**Re: Mitigation Order on Consent Docket No. P-50-06
 Notice of Contingency Plan, Amendment and Response**

**CONTINGENCY PLAN FOR SULFATE WITH RESPECT TO DRINKING
WATER SUPPLIES IN THE VICINITY OF THE FREEPORT-MCMORAN
SIERRITA INC. TAILING IMPOUNDMENT**

MITIGATION ORDER ON CONSENT DOCKET NO. P-50-06

FIGURE 2

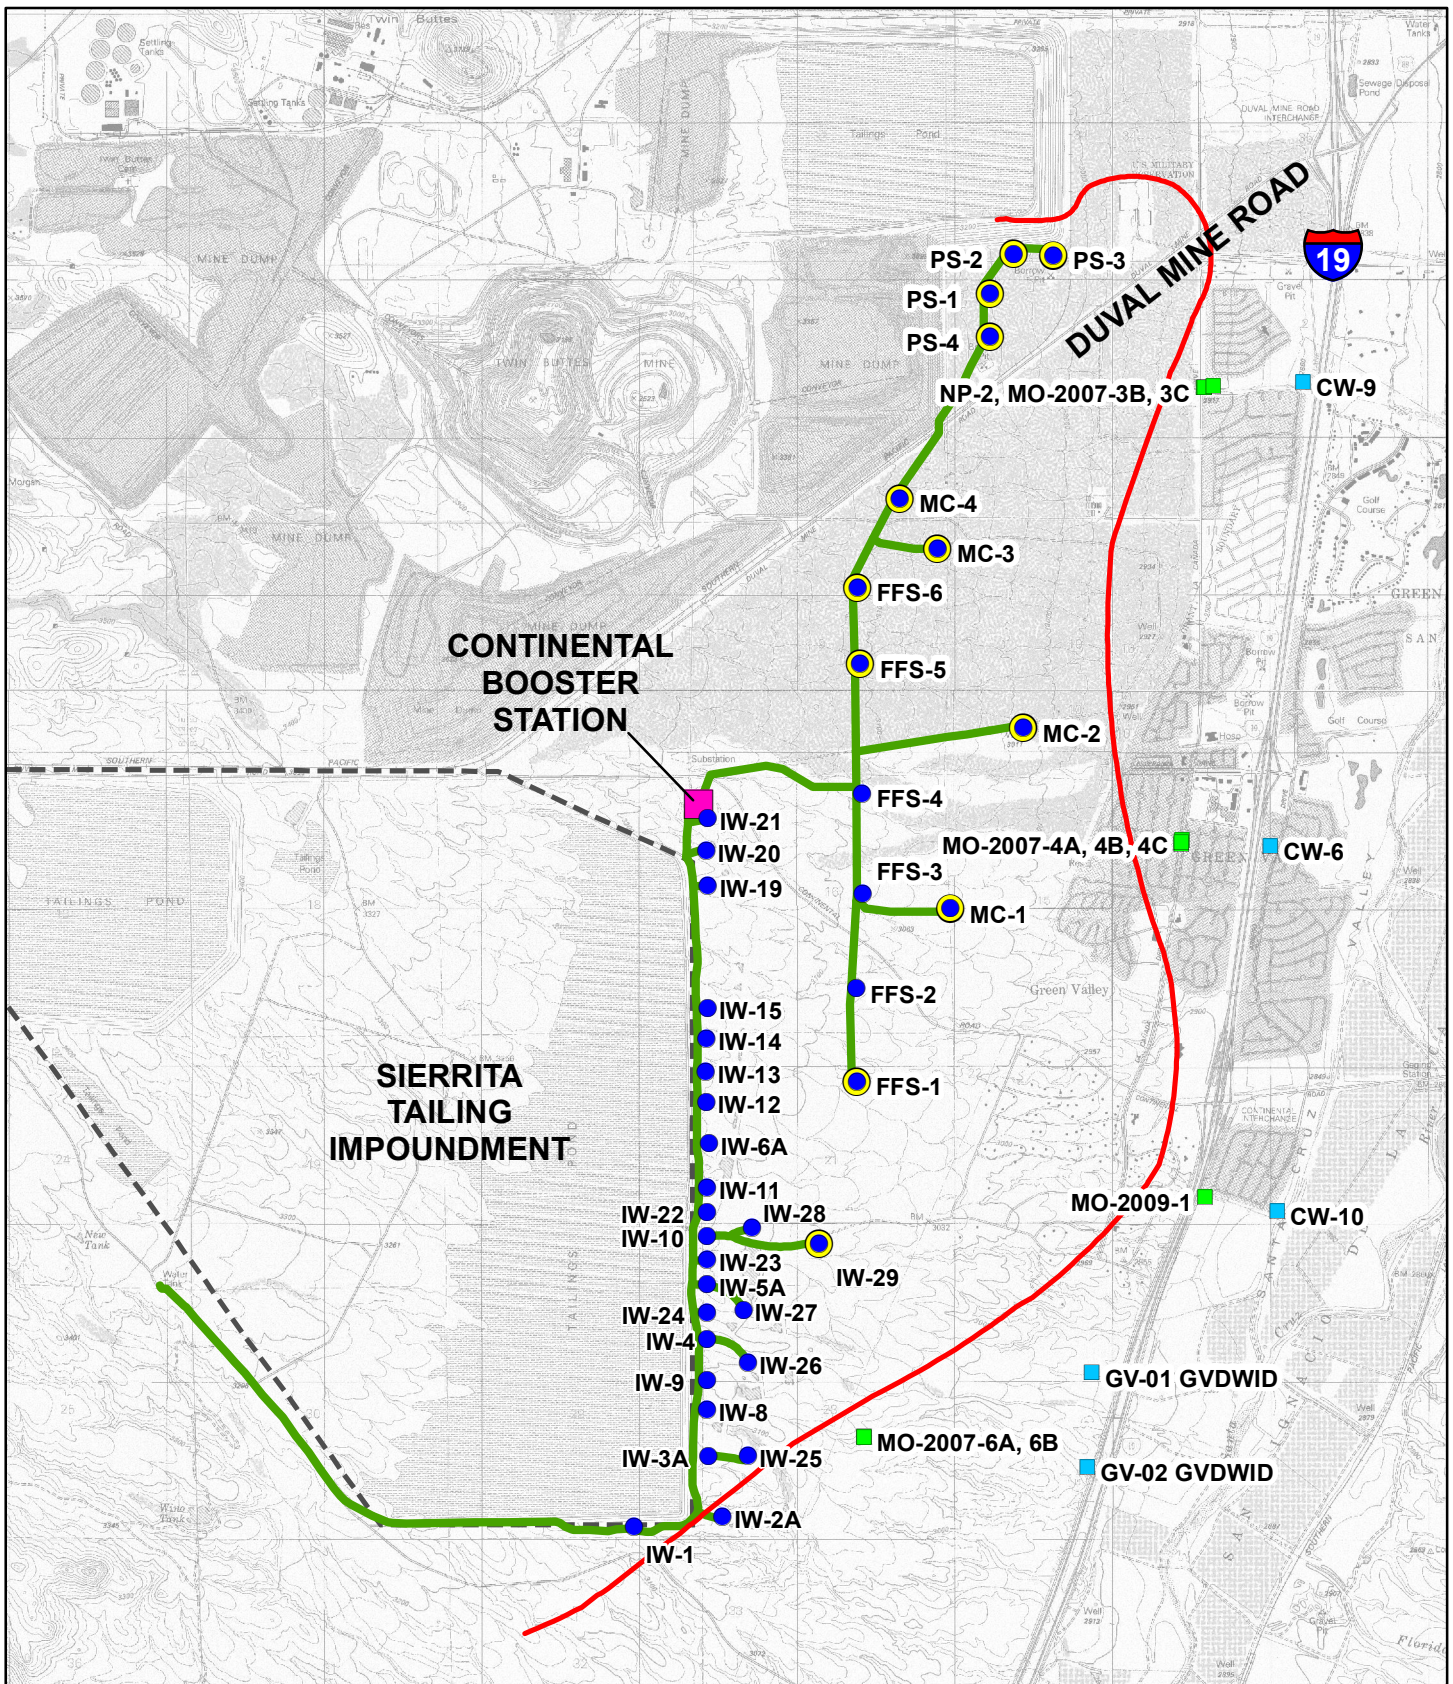
Figure 2 – Sulfate Concentrations in Groundwater, Second Quarter 2015 – FSS well Fss-1 is missing from the figure. The figure should be revised with the location of FSS-1.

Sierrita concurs with ADEQ, Figure 2 is revised to include FFS-1.

FIGURE 3
Mitigation Action
Extraction Wells
and Pumping Facilities

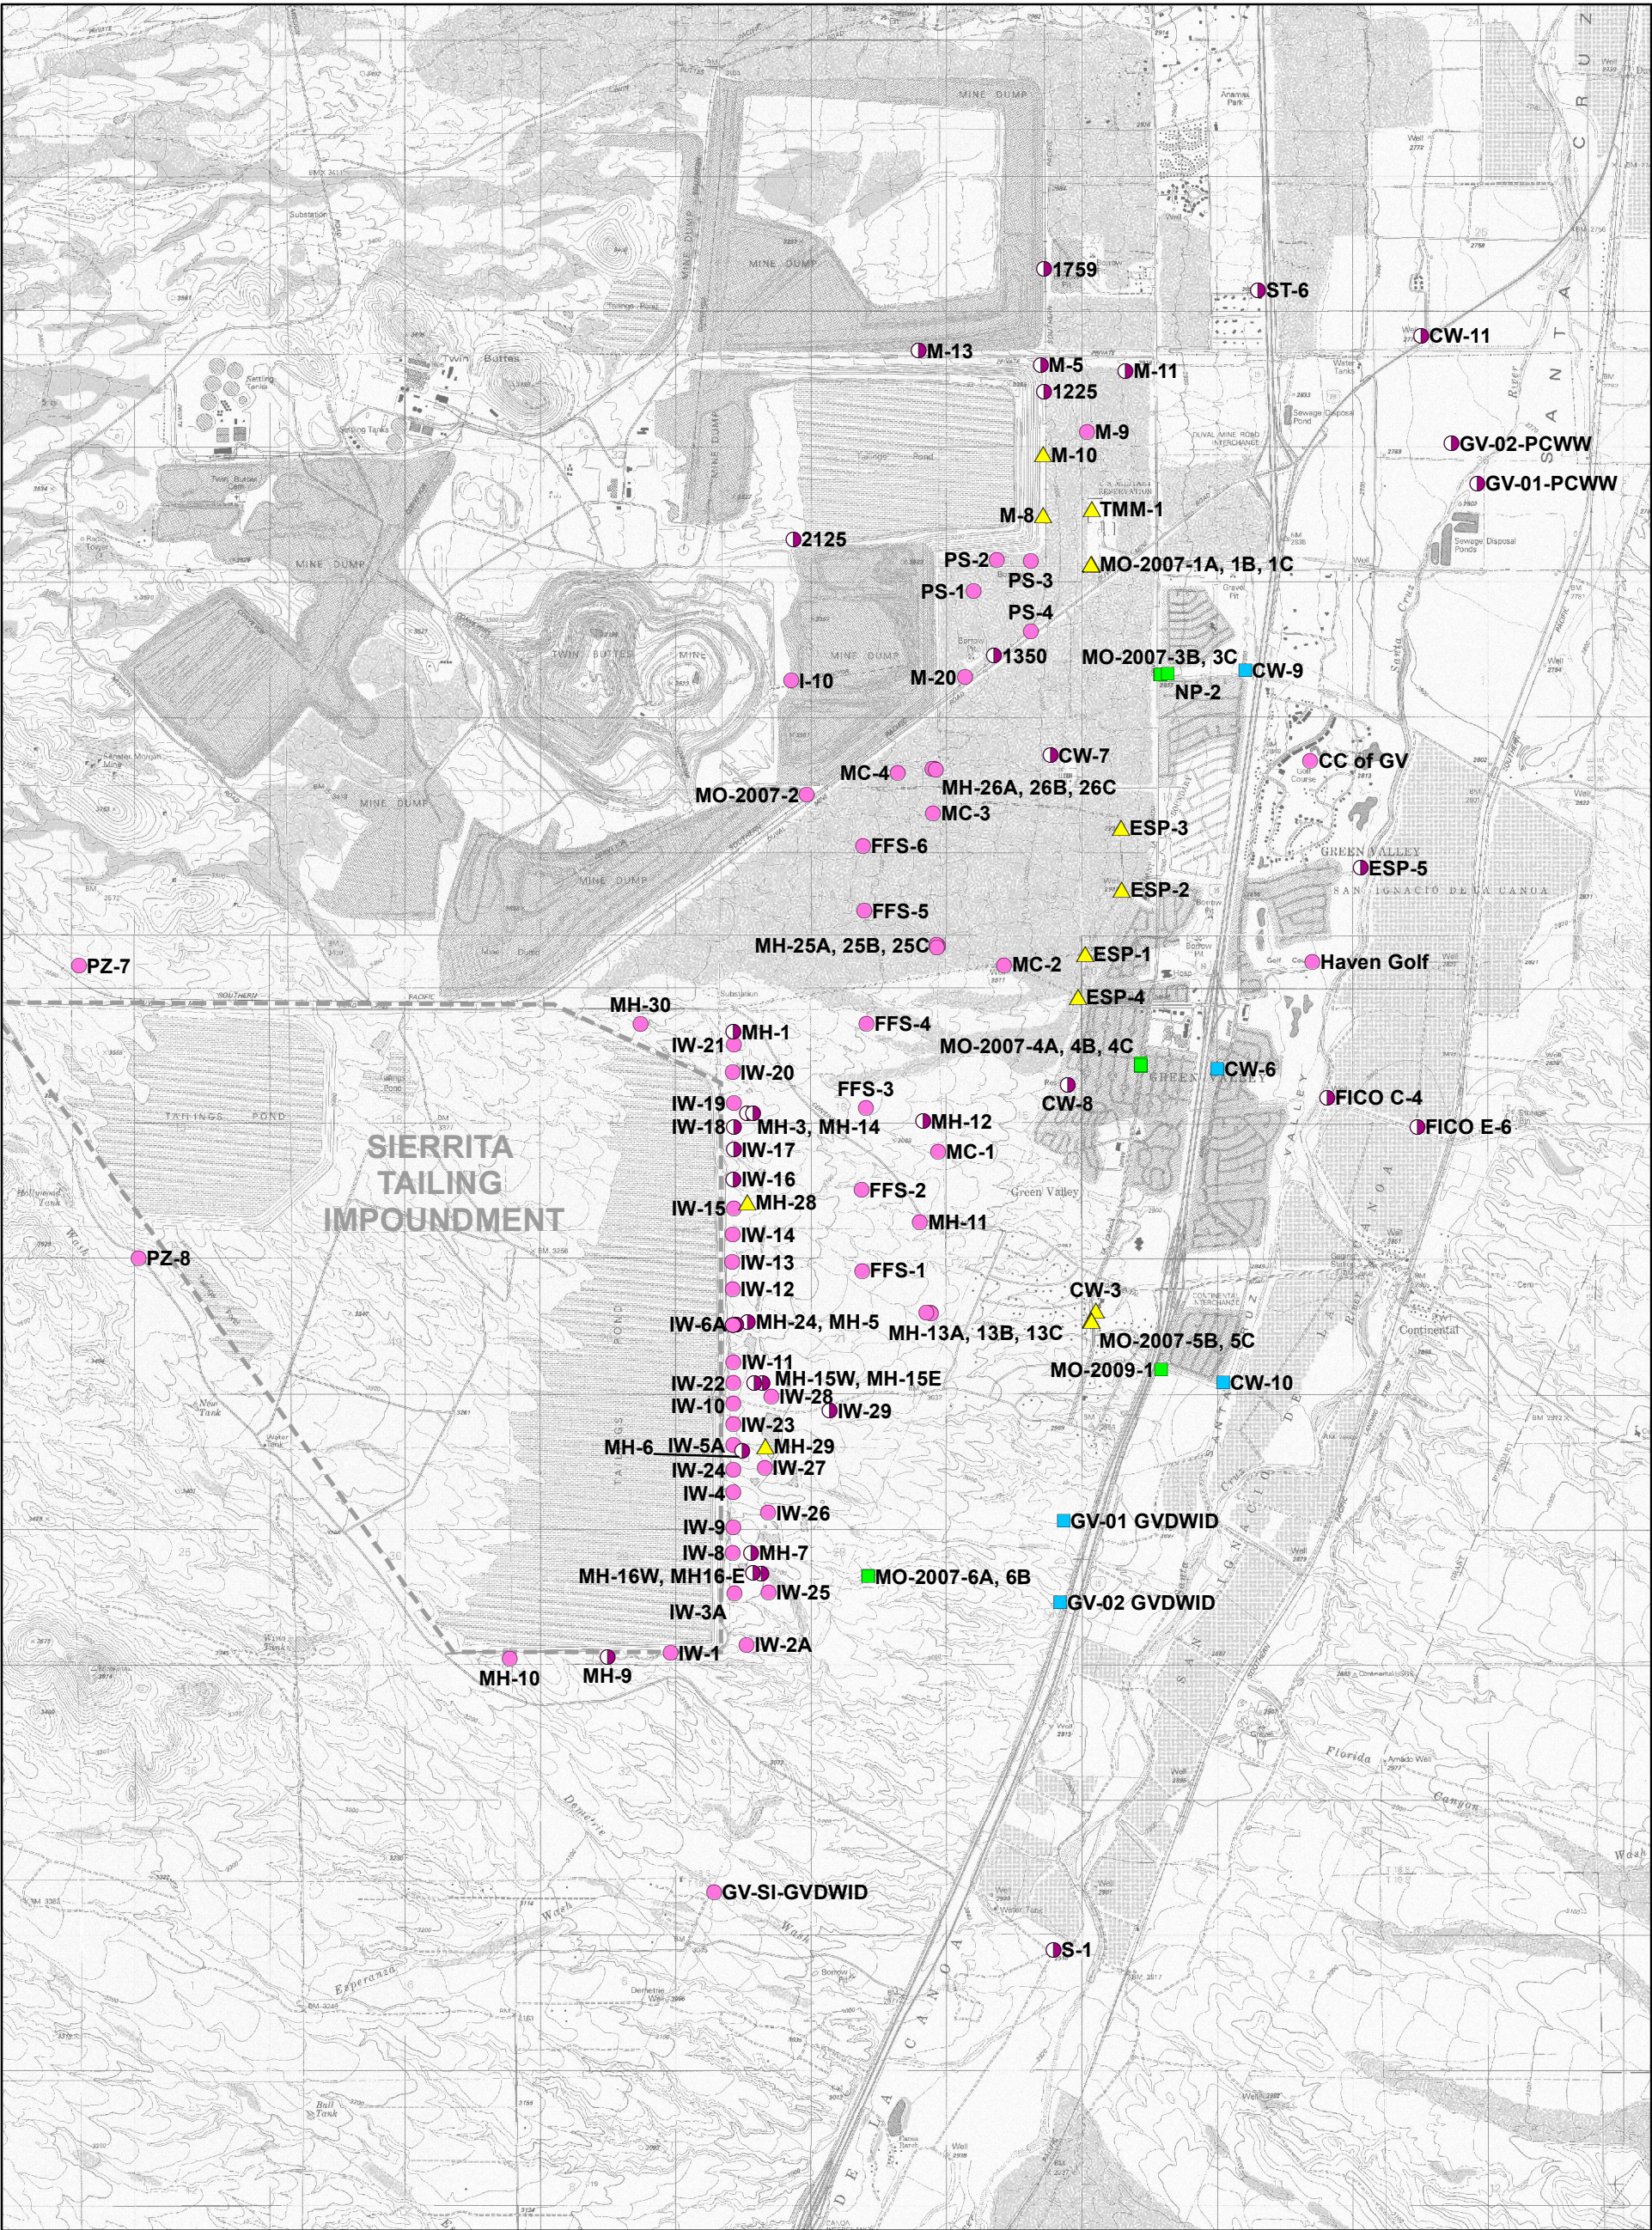
Figure 3 – Mitigation Action Extraction Wells and Pumping Facilities – ADEQ requests that the Mitigation Action Extraction Wells that will be operational be highlighted in this figure.

Mitigation action Extraction Wells and Pumping Facilities – ADEQ requests the location of the drinking water supply wells and the sentinel wells be placed on this figure.

Sierrita concurs with ADEQ, Figure 3 is revised to highlight wells that will be operational during the curtailment.

Sierrita concurs with ADEQ, Figure 3 is revised to include the location of the drinking water supply and sentinel wells.
